PLANNING COMMISSION AGENDA

Tuesday, October 20, 2015
Breckenridge Council Chambers
150 Ski Hill Road

PLANNING COMMISSION MEETING

To: Planning Commission

T1.1
10.06.15
TITLE

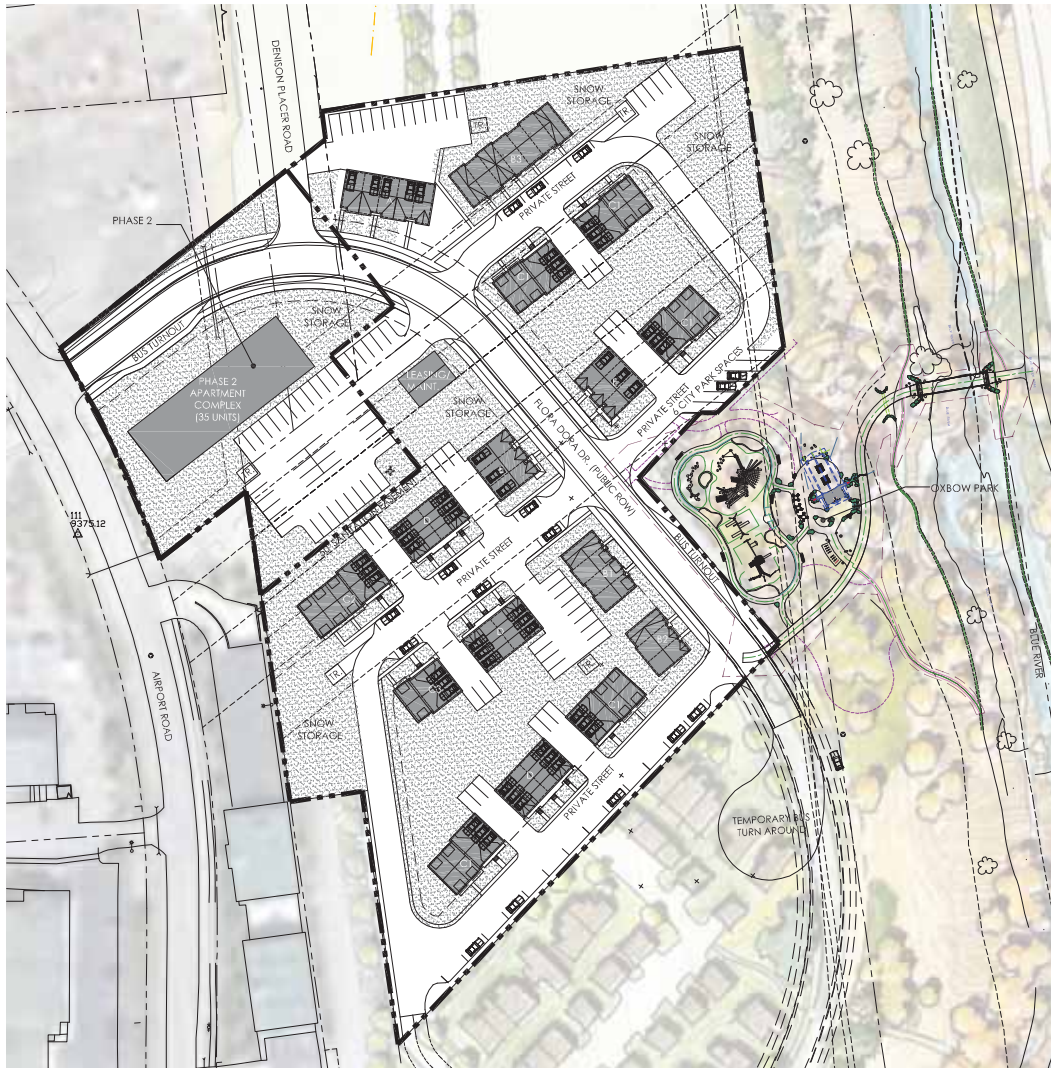
POLICY 15 (RELATIVE) REFUSE: Enclosed dumpsters are required for developments of 6 units or more. Trash dumpsters have been shown and sized to include recycling facilities. Architectural details will be available at the preliminary hearing. Staff believes that the enclosures could be added in Parcel 2 and near the leasing office on Sheet T1.2. Does the Commission concur?
